QUALITY ESPRESSO

TECHNICAL NOTE

21.051-NT

AFTERSALES

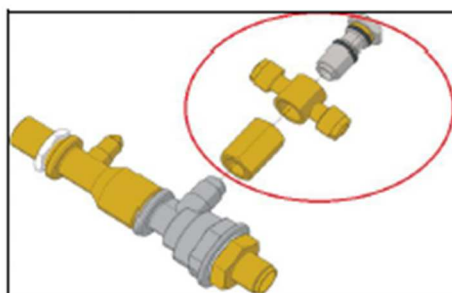
PROBLEM: Sometimes the 1 or 2 way swivel screw breaks during installation.

SOLUTION: The rotary screw mounted on the collector assembly of the OTTIMA (1 and 2 groups) and LA NERA (1 group) coffee machines has been updated.

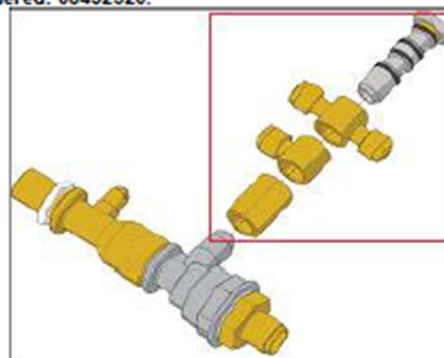
For machines with 2 groups, the affected part is the screw with code 08504510, it is replaced by the new screw with code 08509910. This screw is part of sub-assembly 08492520.

For 2 group machines, the set must be ordered: 08492520.

IMPORTANT: This change must be made only in the assembly position of the manifold assembly with the ret-exp valve of the LA NERA and OTTIMA machines.
